MEMORANDUM

RE: Peer Review of Acoustic Assessment Report
Freymond Quarry
Township of Faraday

**RESPONSE TO PEER REVIEW OF
ACOUSTIC ASSESSMENT REPORT
FREYMOND QUARRY
TOWNSHIP OF FARADAY
DATED JUNE 26, 2017**

ACOUSTIC ASSESSMENT REPORT

Figure 9: Scenario 4: Worst Case, Extraction Area 4, standard hydraulic rock drill in operation on the surface with portable crushing and screening plant in operation in Extraction Area 2 (Day only)

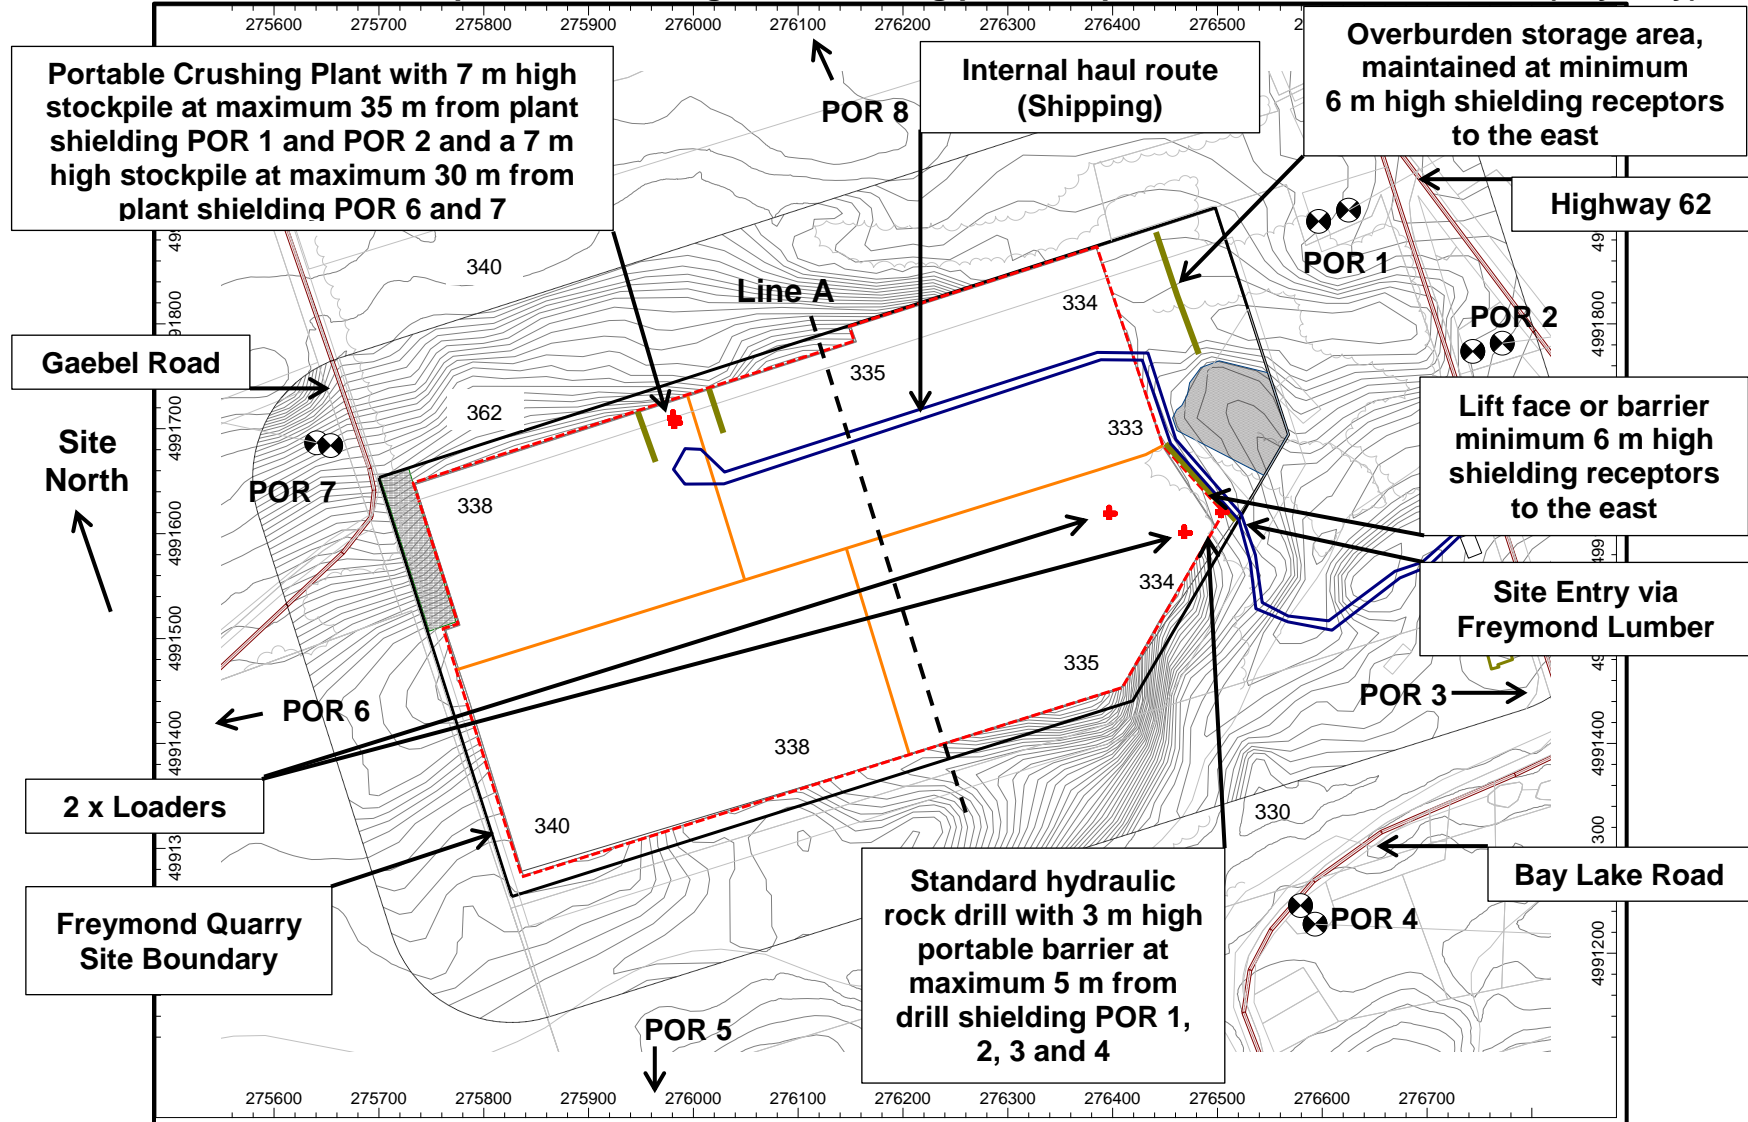
- Recommendation 6 b) does not indicate the maximum distance equipment can operate from the recommended lift face/sound barrier. Figure 9 shows the equipment very close to the lift face. The maximum distance the equipment is permitted to be from the lift face to the east must be indicated.

- Recommendation 6 b) does not indicate the maximum distance equipment can operate from the recommended lift face/sound barrier. Figure 9 shows the equipment very close to the lift face. The maximum distance the equipment is permitted to be from the lift face to the east must be indicated.

- ii. The Phasing Plans will be updated to show the 7 m high barrier to the east of the crushing and screening plant.
 - Recommendation 6 b) in AAR1 does not indicate a maximum distance equipment can operate from the recommended lift face as a maximum distance is not required. Extraction occurs with up to two (2) loaders or excavators. HWA have confirmed this result in the preparation of AAR2.
